SUBJECT: DRESDEN NUCLEAR POWER STATION, UNITS 2 AND 3 - STAFF
ASSESSMENT OF INFORMATION PROVIDED PURSUANT TO TITLE
10 OF THE *CODE OF FEDERAL REGULATIONS* PART 50, SECTION 50.54(f),
SEISMIC HAZARD REEVALUATIONS RELATING TO RECOMMENDATION 2.1
OF THE NEAR-TERM TASK FORCE REVIEW OF INSIGHTS FROM THE
FUKUSHIMA DAI-ICHI ACCIDENT (TAC NOS. MF3877 AND MF3878)

STAFF ASSESSMENT BY THE OFFICE OF NUCLEAR REACTOR REGULATION

RELATED TO SEISMIC HAZARD AND SCREENING REPORT

DRESDEN NUCLEAR POWER STATION, UNITS 2 AND 3

Figure 3.3-1 Plot of Staff's and Licensee's Base Case Shear-Wave Velocity Profiles: (a) Velocity profiles to a depth of 5000 ft [1524 m], (b) Velocity profiles to a depth of 500 ft [152 m] for the Dresden site

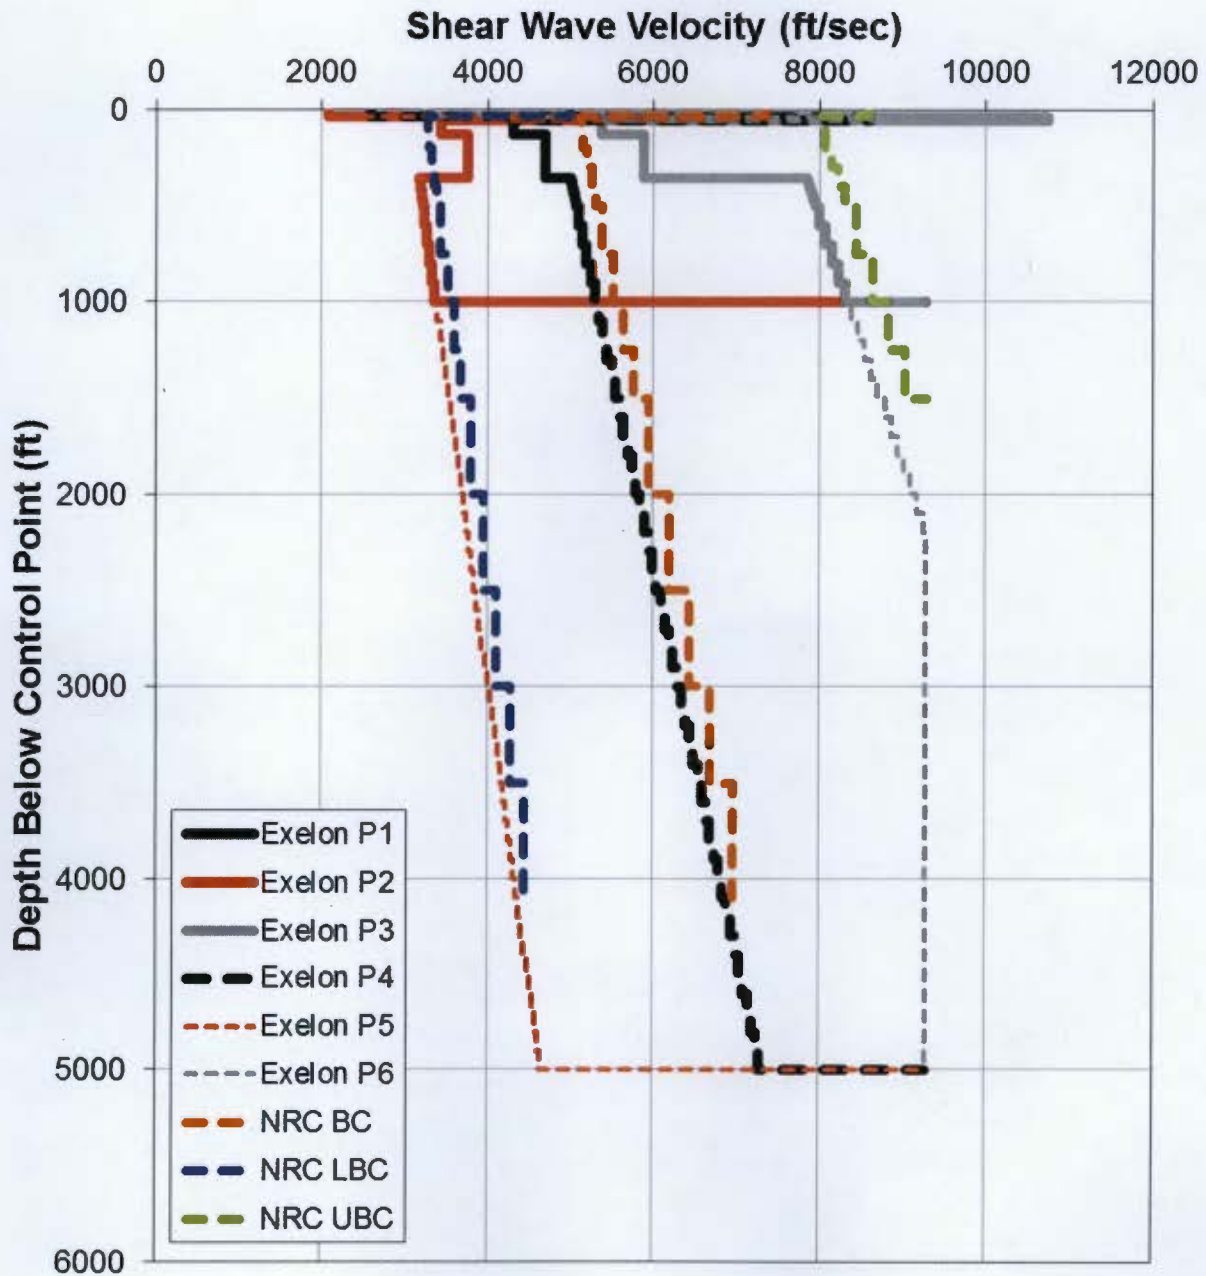
For each of these two best estimate profiles with different depths to the base rock layer, the licensee developed upper and lower base case profiles for a total of six site base case profiles. The licensee developed the upper and lower base case profiles for each of the two best estimate profiles using a natural log standard deviation of 0.20 for the upper 360 ft [110 m] and 0.35 for greater depths. Figure 3.3-1 of this assessment shows the licensee's shear-wave velocity base case profiles.

Because limited velocity information is available for the Dresden site, the staff used three shear wave velocity profiles. For the depth interval between the control point and 50 ft [15 m] below the control point, the staff used an average of the measured compression wave velocities and then assumed a Poisson's ratio to develop its shear wave velocity profile. For depths between 50 ft [15 m] below the control point and the base of the profile, the staff assumed the shear wave velocity increased linearly, consistent with guidance from the SPID. To capture the uncertainty in the depth to base rock, the staff used a depth of 4,100 ft [1250 m] for its lower and middle base case profiles and a depth to base rock of 1,500 ft [457 m] for its upper base case profile. The staff introduced additional uncertainty in the depth to base rock by randomizing the depth to base rock by ± 30 percent of the total profile thickness. Figure 3.3-1 of this assessment shows the staff velocity profiles compared to the profiles developed by the licensee.

The largest difference between the staff's and licensee's velocity profiles is in the upper 35 to 360 ft [11 – 110 m], which is primarily due to defining the control point at slightly different elevations and the staff applying larger uncertainty to develop its lower and upper base case profiles. Regarding the control point elevation, the reactor building foundation is supported on Ordovician Divine limestone at an elevation of 472.5 ft [144 m]. The staff used the top of this geologic unit as the control point, while the licensee used the top of the uppermost rock unit, the Pennsylvanian Pottsville Formation sandstone as the control point (515 ft [74.7 m]). Additionally, rather than develop six base case profiles, the staff developed only three profiles, as described above. To develop its lower and upper base case velocity profiles, the staff used a natural log standard deviation of 0.35, which is the value recommended by the SPID for sites with limited subsurface data.

Figure 3.3- 1 Plot Comparing the Staff's and the License's Median Amplification Functions and Uncertainties for two input loading levels for the Dresden site

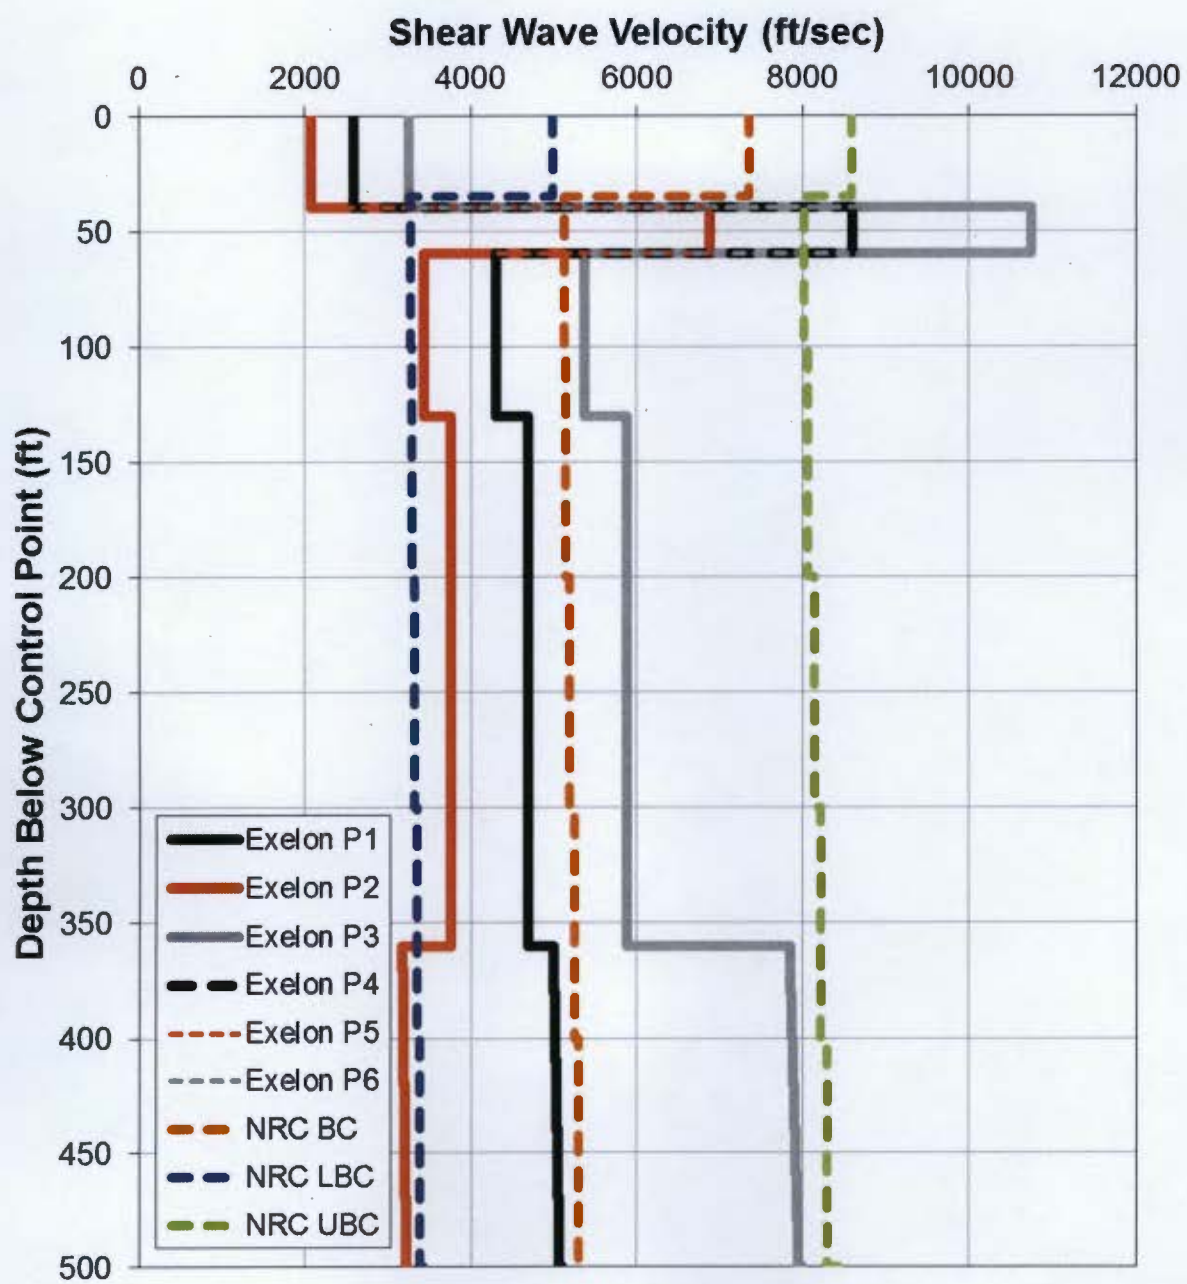
Figure 3.3-2 of this assessment shows a comparison of the staff's and licensee's median site amplification functions and uncertainties (± 1 standard deviation) for two of the eleven input loading levels. The comparison of amplification functions is for the licensee's profile P1 and the staff's base case profile. The licensee's amplification functions are moderately higher than the staff's amplification functions near 1 Hz and between 5 – 15 Hz. The differences above 5 Hz are primarily due to the different control point elevations assumed by the staff and licensee while the differences at 1 Hz are due to the licensee's use of two sets of profiles with different depths to bedrock at 1,000 ft [305 m] and 5,000 ft [1524 m]. The staff used a depth to base rock of 4,100 ft [1250 m] for its lower and middle base case profiles and a depth to base rock of 1,500 ft [YYY m] for its upper base case profile.

Overall, the licensee's approach to modeling the subsurface rock properties and their uncertainty results in higher site amplification factors, particularly at high frequencies. As shown in Figure 3.3-3 of this assessment, these differences in the site response analysis do not have a significant impact at 1 Hz and only a moderate impact above 5 Hz on the control point seismic hazard curves and the resulting GMRS, as discussed below. Appendix B of the SPID provides guidance for performing site response analyses, including capturing the uncertainty for sites with less subsurface data; however, the guidance is neither entirely prescriptive nor comprehensive. As such, alternative approaches in performing site response analyses, including the modeling of uncertainty, are acceptable for this application.

Figure 3.4-1 Comparison of the Staff's GMRS with Licensee's GMRS and the SSEs for the Dresden site

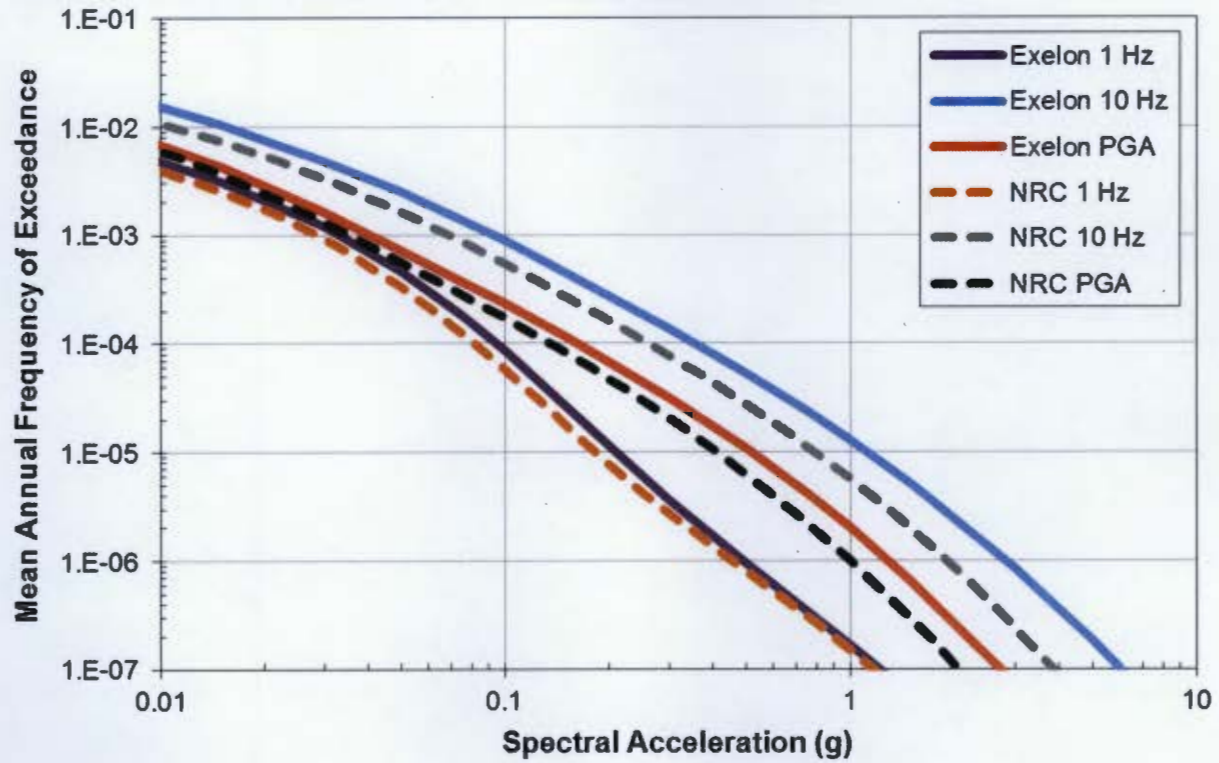
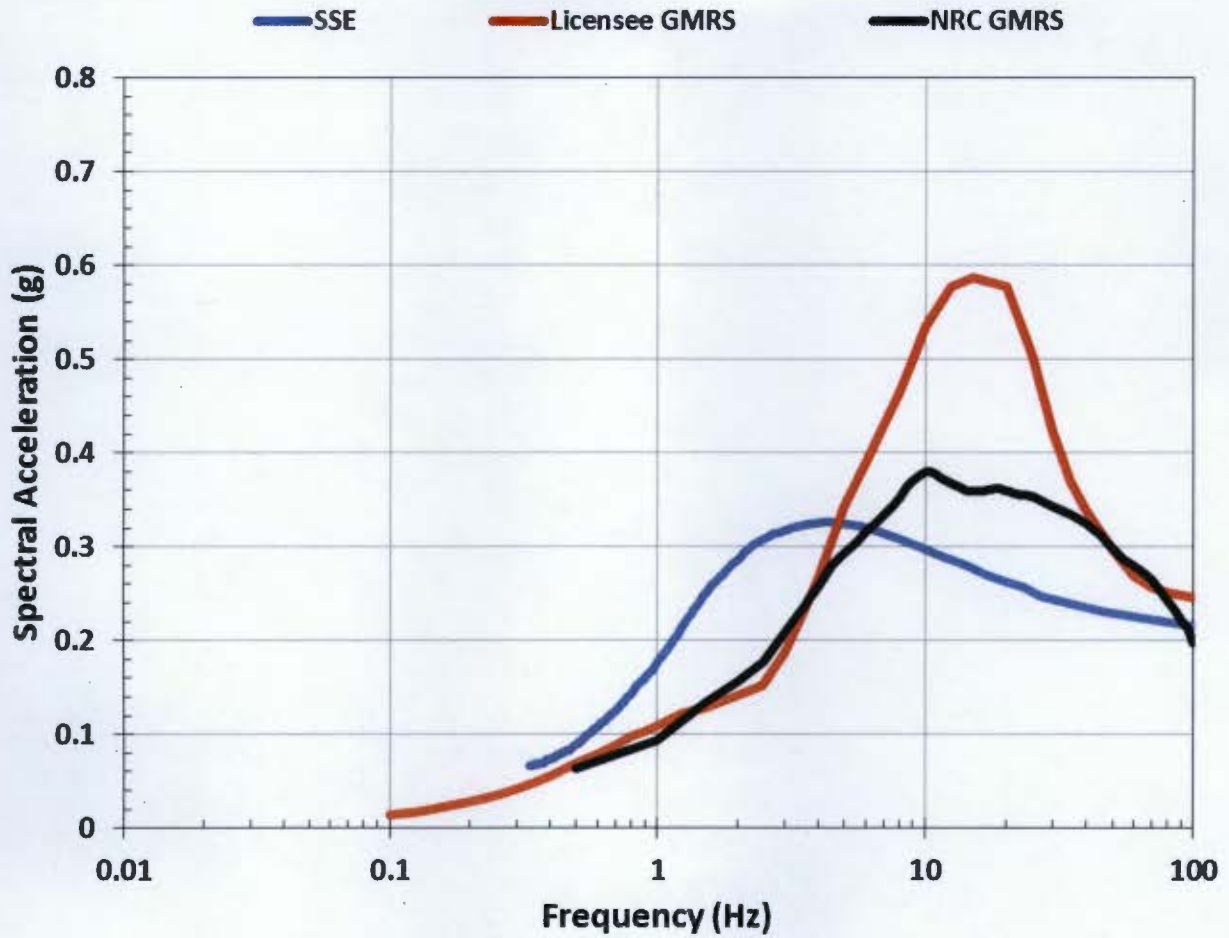
The staff independently calculated the 10^{-4} and 10^{-5} UHRS using the results of its confirmatory PSHA and site response analyses, as described in Sections 3.2 and 3.3 of this staff assessment, respectively. Figure 3.4-1 of this assessment shows a comparison of the GMRS determined by the licensee to that determined by the staff.

As shown in Figure 3.4-1 below, the licensee's GMRS shape is generally similar to that calculated by the staff at frequencies less than 5 Hz. However, NRC staff's confirmatory GMRS is somewhat lower than the licensee's at frequencies above 5 Hz. As described above in Section 3.3, the staff concludes that these differences over the higher frequency range are primarily due to the differences in the site response analyses performed by the licensee and staff. The staff concludes that these differences are acceptable for this application because the licensee followed the guidance provided in the SPID with respect to both the PSHA and site response analysis for the Dresden site.

The staff confirms that the licensee used the present-day guidance and methodology outlined in RG 1.208 and the SPID to calculate the horizontal GMRS, as requested in the 50.54(f) letter. The staff performed both a PSHA and site response confirmatory analysis and achieved results generally consistent with the licensee's horizontal GMRS. As such, the staff concludes that the GMRS determined by the licensee adequately characterizes the reevaluated hazard for the Dresden site. Therefore, this GMRS is suitable for use in subsequent evaluations and confirmations, as needed, for the response to the 50.54(f) letter.
